SIMPLOT SMOKEY CANYON MINE
NON-TIME-CRITICAL REMOVAL ACTION (NTCRA)

ENGINEERING CHANGE ORDER (ECO)

ECO # 1	DATE: APRIL 28, 2015
TITLE: Dinwoody Borrow Sedimentation Basin Spillway Modification	
DEGREE OF DESIGN MODIFICATION:	
INSIGNIFICANT – Minor change to drawings or specifications. No impact to NTCRA	<input checked="" type="checkbox"/> Agency concurs that no approval is required <input type="checkbox"/>
SIGNIFICANT – Major change to design resulting in altered NTCRA	<input type="checkbox"/> Agency approval of revised documents is required prior to construction <input type="checkbox"/>
DESCRIPTION OF MODIFICATION:	
<p>In lieu of ½ round CMP across the spillway crest of the south and north sedimentation basin embankments, riprap will be utilized as illustrated on the attached drawing. This is consistent with other ½ round CMPs in the NTCRA design, for which riprap spillways are identified as an alternative. 🕒</p> <p>The design change does not change the hydraulic capacity or functionality of the spillway. As shown on the drawing, the flow capacity of the south basin riprap lined spillway is 29.7 cubic feet per second (cfs) and the capacity of the north basin riprap lined spillwa

BORROW AREA SEDIMENTATION BASIN SPILLWAYS - ECO

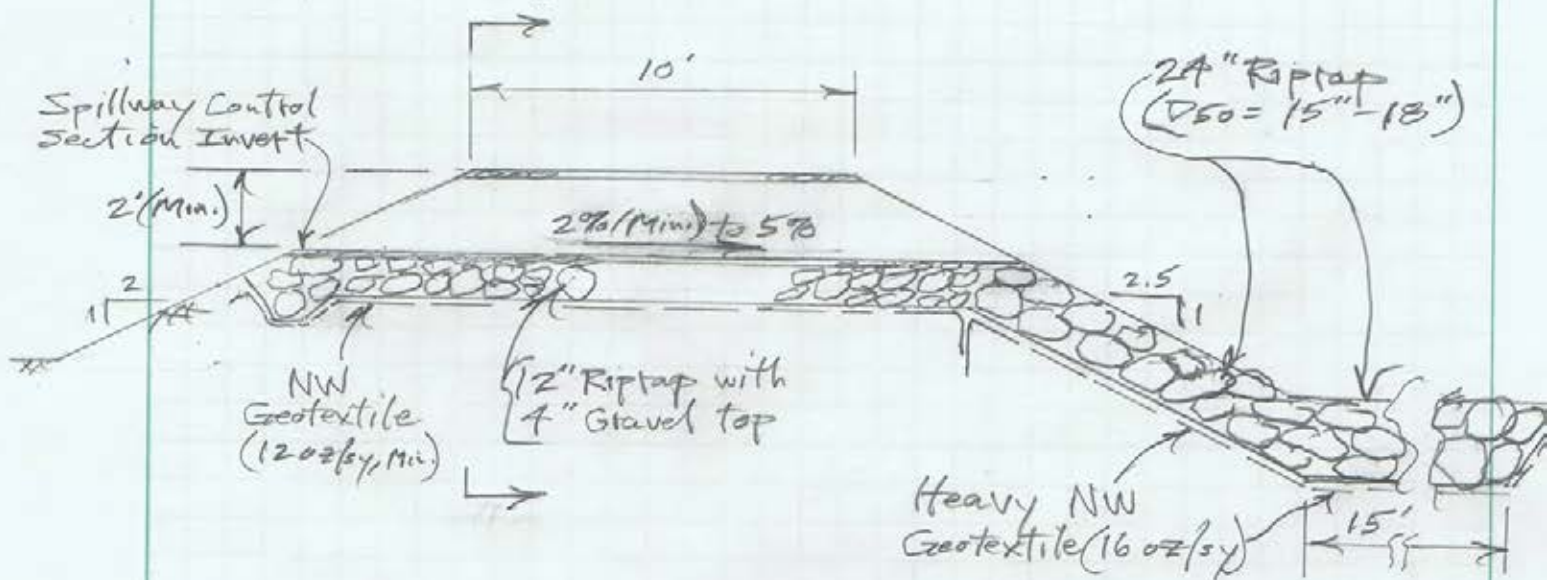
JUSTIFICATION/BENEFIT:	
1) Owner's request. 2) Will allow vehicle access across spillway as required for maintenance.	
PREPARED BY: FORMATION ENVIRONMENTAL, LLC on behalf of the J.R. Simplot Company  Brian G. Hansen, PE	APPROVED BY:

1 ft. Steepest (min)
 $Q = CL(H)^{3/2}; H = 1 \text{ ft.}$
 $C = 2.7; L = \left(\frac{13+9}{2}\right) = 11 \text{ ft}$
 $Q = 2.7(11)(1)^{3/2} = 29.7 \text{ cfs}$
 $\geq 23 \text{ cfs (So. Basin)}$
 $Q = 2.7(6)(1)^{3/2} = 16.2 \text{ cfs}$
 $\geq 8 \text{ cfs (No. Basin)}$
 OK

TYPICAL SECTION - SEEP DRAINAGE
COLLECTION & CONTROL UNDER DRAIN SYSTEM

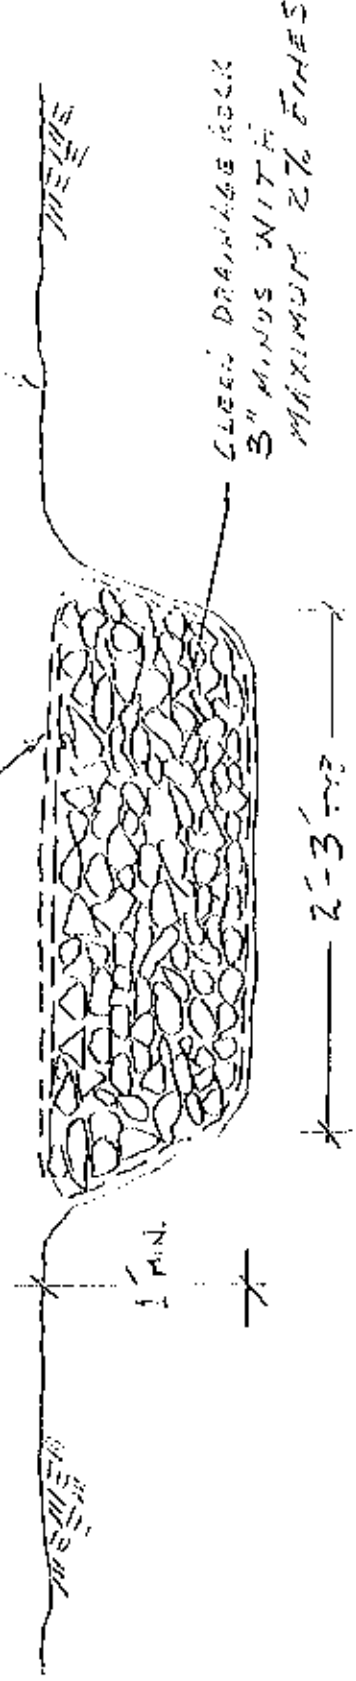
DESCRIPTION OF MODIFICATION: <p>During foundation preparation activities (i.e., clearing, grubbing, and topsoil removal) conducted during the month of April west and northwest of the South Central Sedimentation Basin area, two discrete seeps were revealed in native ground near the juncture with the east side of the existing mine haul road. This area will be covered, for the most part, by the NTCRA construction regrade and cover system. This seepage zone is being referenced as the South Central Sedimentation Basin seep area. Initial observations indicated that seepage flow is typically 1 to 2 gallons per minute (gpm) during relatively dry periods. During periods of precipitation, the number of seeps increased to seven discrete seepage areas with a combined flow of nearly 5 gpm. The number of seeps, and the combined seepage flow rate, increase during periods of precipitation and decrease immediately following precipitation events.</p> <p>Samples of the original seeps, and a composite sample of the two seeps, were collected on April 22, 2015 and submitted to SVL Analytical for analysis of selenium and general chemistry, including major ions. The analytical results along with respective Piper diagrams, Stiff diagrams, and cation/anion balance information are included as Attachment 1. Conclusions drawn from the reported analytical data are as follows:</p> <ul style="list-style-type: none"> Total selenium concentrations were measured at 0.0094 and 0.0184 mg/L (composite 0.0171 mg/L). These concentrations are in the low end of the range for seeps across the mine, and are most similar to the concentrations measured at seep ES-3. Chloride concentrations were measured at 234 and 503 mg/L (composite 368 mg/L). These concentrations indicate an influence from the mine-related sources (possibly use of magnesium chloride as a dust control agent), and are similar to concentrations measured for various stormwater detention basins at the mine. Nitrate concentrations were measured at 2.27 and 5.62 mg/L (composite 3.45 mg/L). These concentrations may indicate a potential influence from the blasting compound, and are similar to concentrations measured for seep ES-3, shallow groundwater wells GW-15 and GW-22, Wells Formation groundwater well GW-24, and the Industrial Well. <p>These analytical results indicate that the seep water chemistry is consistent with other mine runoff waters.</p>

The primary purpose of this ECO is to provide a means for conveying the seep waters out of the embankment that will be constructed in the south-central part of the project area. Removal of the seeps will reduce pore pressures within the embankments and promote stability.

Seepage relief will consist of drainage rock wrapped in non-woven geotextile placed in a 1- to 2-foot deep and 3-foot wide trench excavated into the existing native ground ("under drain") and directed from near the point where the seeps emanate to a temporary discharge point located south and away from the ODA southern limits. The locations of the seeps are indicated on Photograph 1 and the attached drawing that was cropped from DWG 009-001-C7. The underdrain discharge location and seep under drain alignment are also indicated on the attached drawing. A typical section of the under drain is illustrated in the attached Figure 1. Conditions will be assessed at the time of excavation for the under drain and, if it is deemed prudent, the under drain system may be expanded for more effective seep capture.

The under drain system, as designed, will convey flows significantly greater than those observed at the seeps, will help to eliminate excess pore pressures in the regraded NTCRA construction components, and will create much dryer soil conditions allowing for construction to continue in the area. The hydraulic relief provided by the underdrain will promote and maintain the stability of the overlying embankment.

J.R. SIMPLOT COMPANY - SMOKY CANYON MINE			
POLE CANYON ODA-NTCRA			
GRADING PLAN			
POLE CANYON ODA EAST AREA			
DATE	DECEMBER 2014	DWG. NO.	009-004-C2
REVISION			3

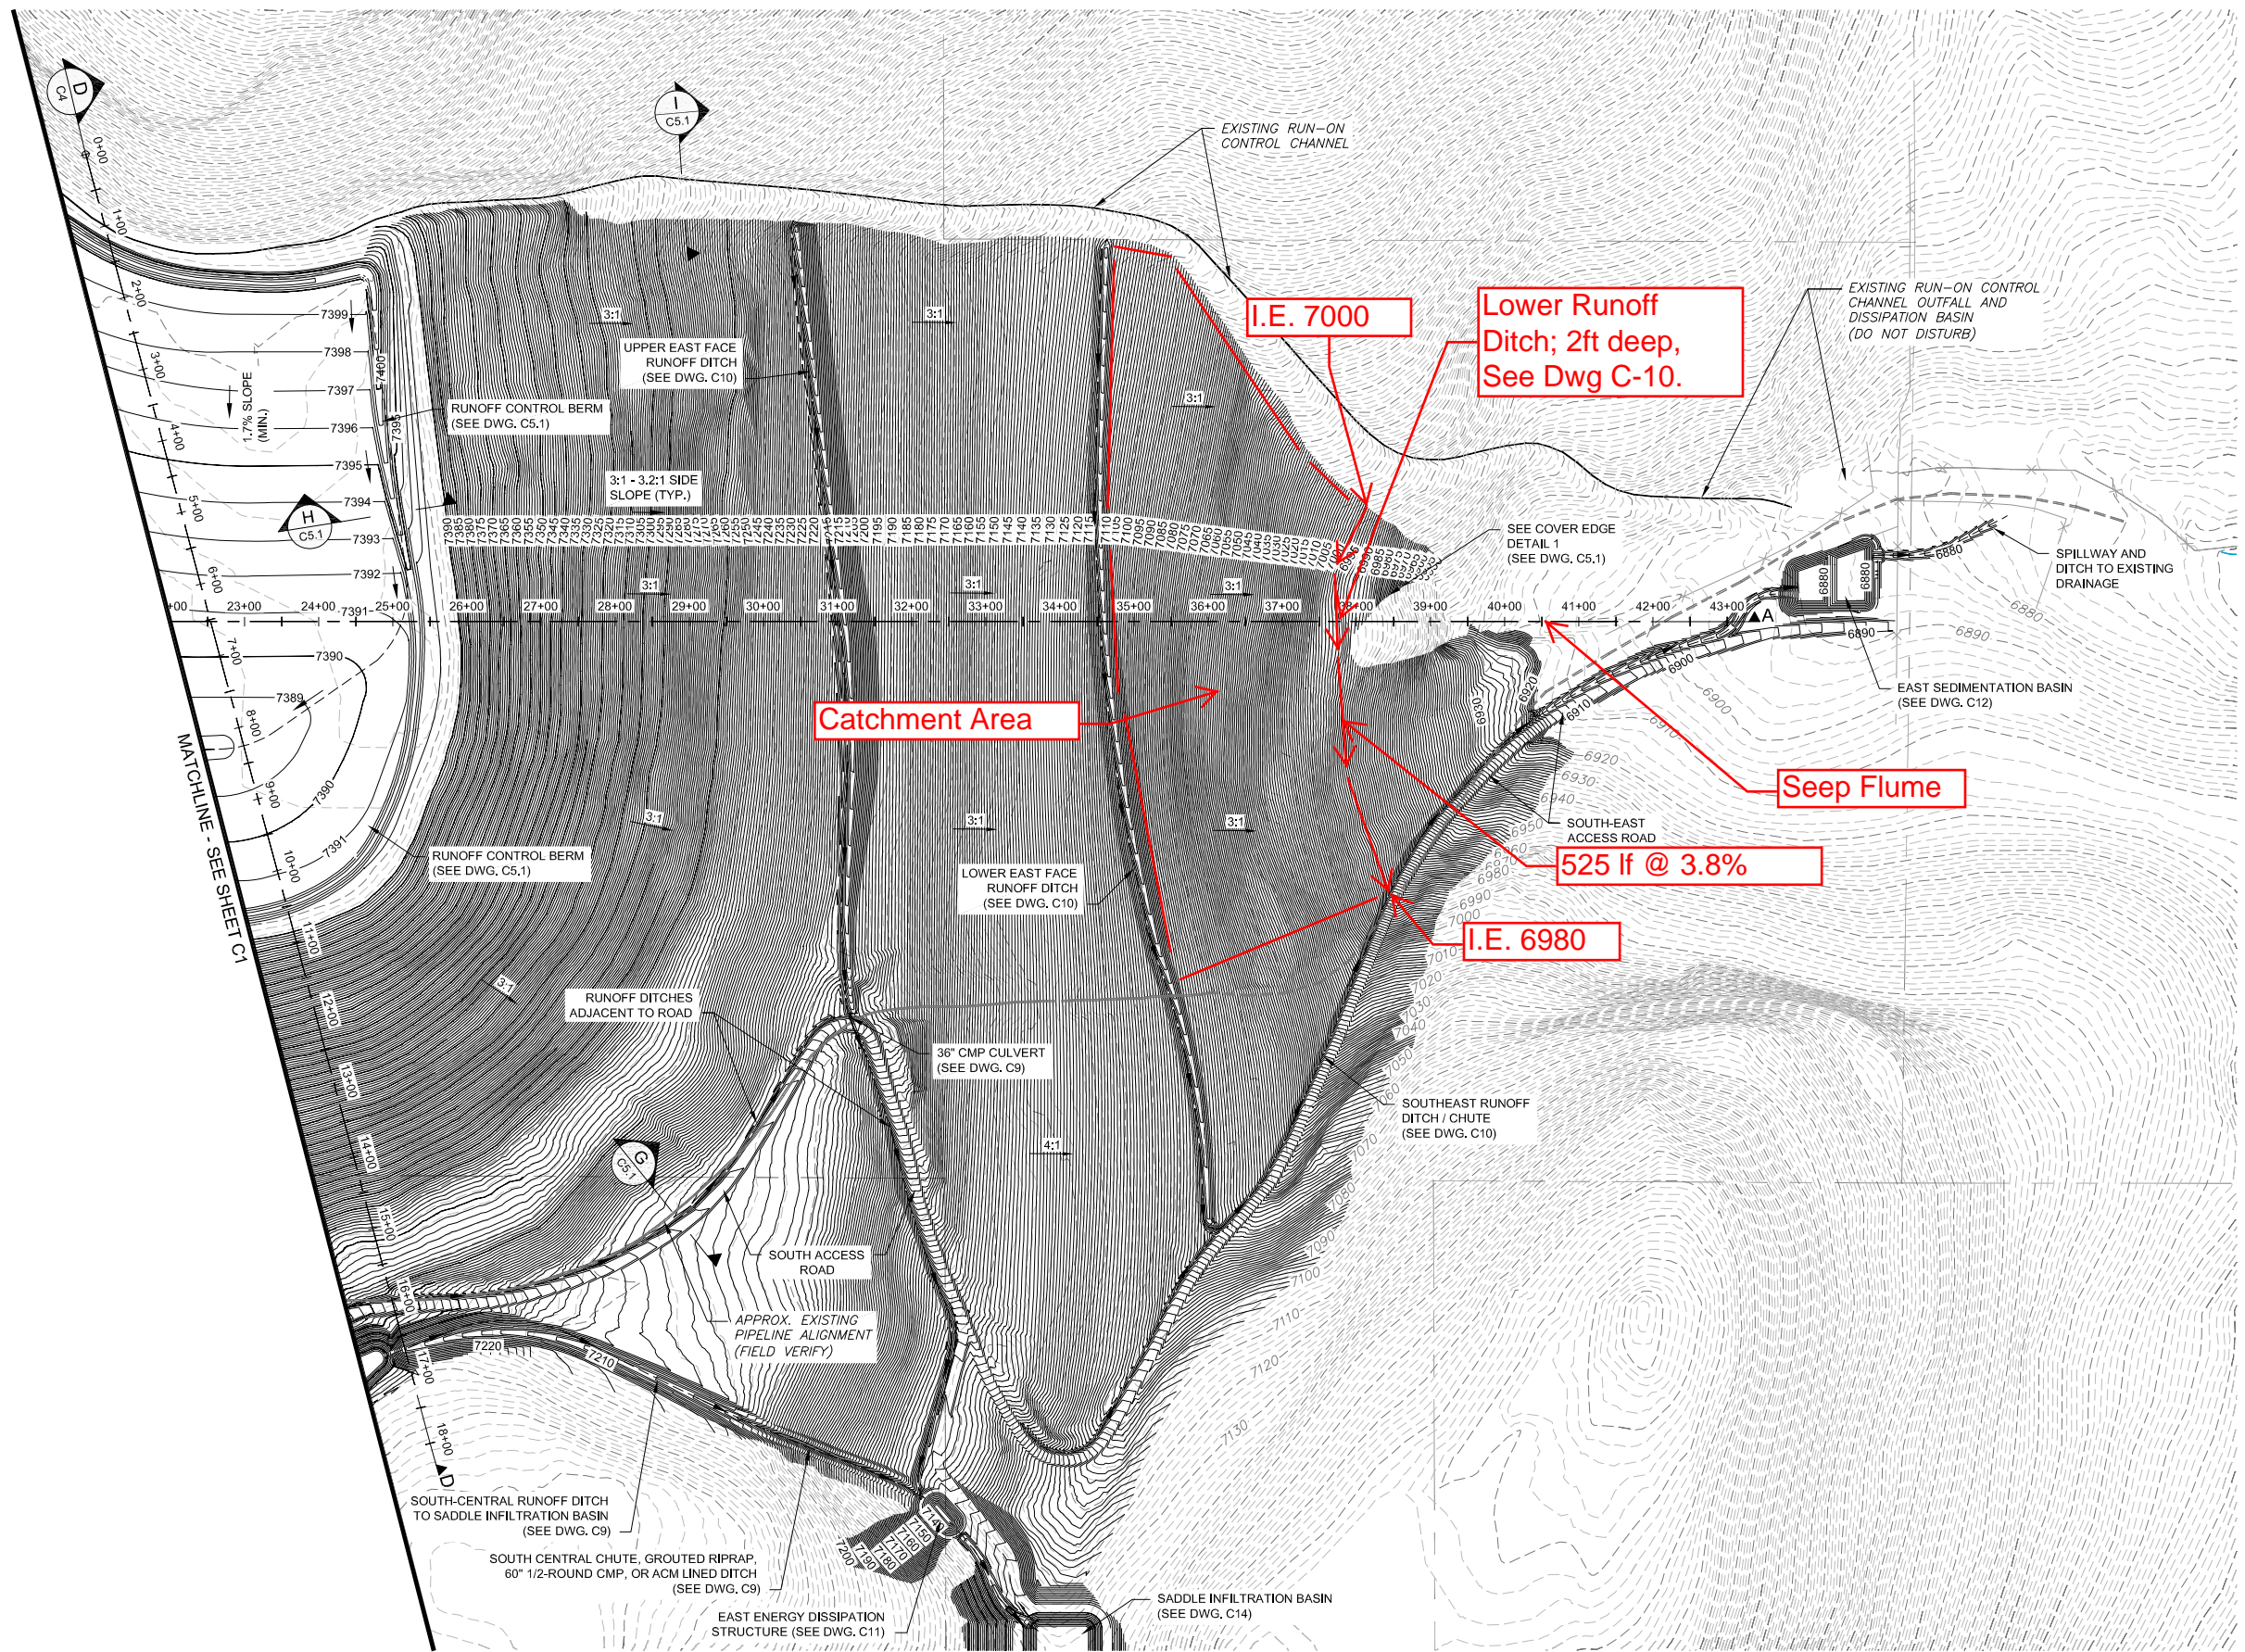
ECO # 3	DATE: MAY 5, 2015
TITLE: RUN-OFF CONTROL CHANNEL EAST TOE OVERBURDEN DISPOSAL AREA	
DEGREE OF DESIGN MODIFICATION:	
INSIGNIFICANT – Minor change to drawings or specifications. No impact to NTCRA	<input checked="checked" type="checkbox"/> Agency concurs that no approval is required <input type="checkbox"/>
SIGNIFICANT – Major change to design resulting in altered NTCRA	<input type="checkbox"/> Agency approval of revised documents is required prior to construction <input type="checkbox"/>
DESCRIPTION OF MODIFICATION:	
<p>In order to capture, control, and divert clean surface water run-off from a small catchment area of approximately 2.3 acres on the east toe of the Overburden Disposal Area, a relatively small water diversion channel will need to be constructed. The catchment area and channel alignment are illustrated on the attached drawing (DWG 009-004-C2). Diversion of runoff flows will be toward the south runoff ditch. Considering the maximum 100 yr, 24 hr storm event, runoff from the catchment area can create a peak flow of approximately 3 cubic feet per second. Using Manning's hydraulic engineering equation and a roughness coefficient of 0.03, a 2 ft deep open V channel with 2(h):1(v) side slopes having similar geometric cross section as detailed in the attached drawing (DWG 009-001-C10), sloping 3.8% from intake invert to outflow invert will have adequate capacity to divert and contain the flow from a 100-yr, 24-hr storm event. This will provide a freeboard in excess of 1 foot and will have a peak velocity of approximately 4.1 fps.</p> <p>Engineering guidelines and specifications that have been approved for the Pole Canyon NTCRA (August 2014 Final Removal Design Report) indicate that open channel water diversions with estimated peak flows of less than 5 feet per second (fps) can be protected from erosion through seeding and vegetation and that diversions with estimated peak flows of between 5 and 10 fps can be protected from erosion through the use of turf reinforcement mats (TRMs). As noted above, the estimated peak flow for subject runoff control channel is 4.1 fps. Though this estimate is below 5 fps, the channel will be constructed with TRM to conservatively protect against erosion during peak flows. The new ditch will tie into the Southeast Runoff Ditch/Chute in the same manner as the Lower East Face Runoff Ditch.</p>

JUSTIFICATION/BENEFIT:	
<p>The construction of a run-off control channel at the east toe of the ODA will prevent clean runoff water from mixing and comingling with water currently discharging at the ODA toe, which contains selenium and other contaminants of concern, thus limiting the volume of contaminated water that evaporates and/or infiltrates to the subsurface in the area east of the ODA toe.</p>	
PREPARED BY: FORMATION ENVIRONMENTAL, LLC on behalf of the J.R. Simplot Company  Brian G. Hansen, PE	APPROVED BY:
